**REQUEST**

Current Zoning: R-22MF (multifamily residential)  
Proposed Zoning: UR-2(CD) (urban residential, conditional)

**SUMMARY OF PETITION**

**STAFF  
RECOMMENDATION**

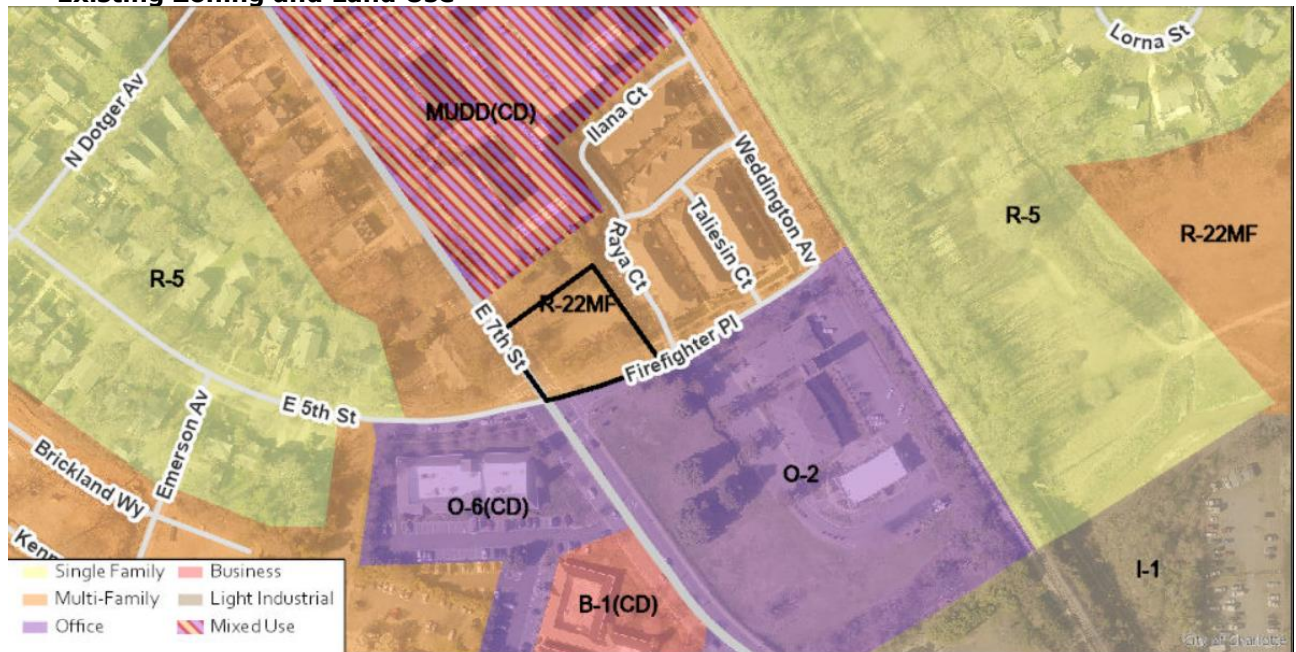
The site plan accompanying this petition contains the following provisions:

- Limits the number of alley-fed single family attached (townhome) units to 10 for a density of 22.61 units per acre.
- Limits the building height to 48 feet.

- Proposes ingress/egress onto Firefighter Place.
- Provides 8-foot sidewalk and 8-foot planting strip along East 7<sup>th</sup> Street and Firefighter Place frontages.

- Installs a 6-foot shared sidewalk along easternmost units, to tie into proposed sidewalk along Firefighter Place.
- Proposes architectural and landscaping standards related to exterior building materials, pitched roofs, corner/end units, blank wall provisions, and rooftop terraces.

- Provides 10-foot vegetated area and 8-foot high retaining wall along the north property line to be planted to Class C buffer standards. Notes vegetated area may be eliminated if abutting parcel with existing single family residential home is redeveloped to a use other than single family residential.

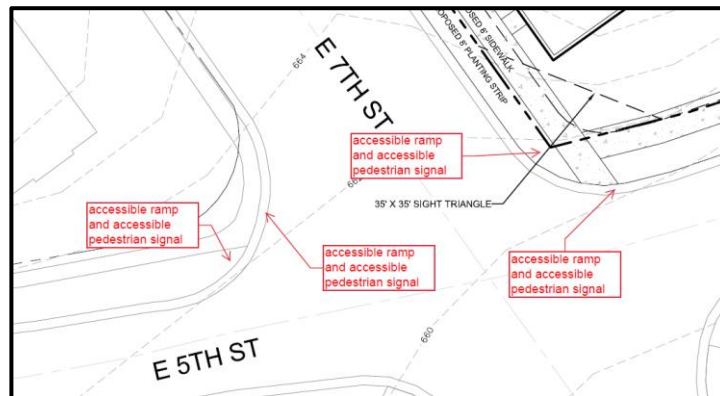
- ~~1. The petitioner should revise the site plan and conditional note(s) to commit to construct dual ramps at the corner of E 7th Street and E. 5th Street to meet the City's Charlotte WALKS Policy and PROWAG. In addition, the developer should commit to provide accessible push buttons for its corner. The site plan should label and dimension both items from the back of curb and gutter and road centerline.~~ Rescinded

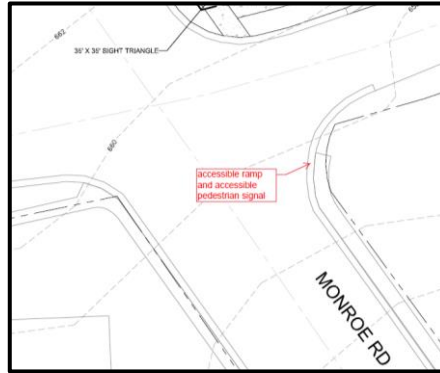
- ~~2. The petitioner should revise the site plan and conditional note(s) to commit to construct dual ramps at the corner of Monroe Road and E. 5th Street to meet City's Charlotte WALKS Policy and PROWAG. The site plan should label and dimension both items from the back of curb and gutter and road centerline.~~ Rescinded
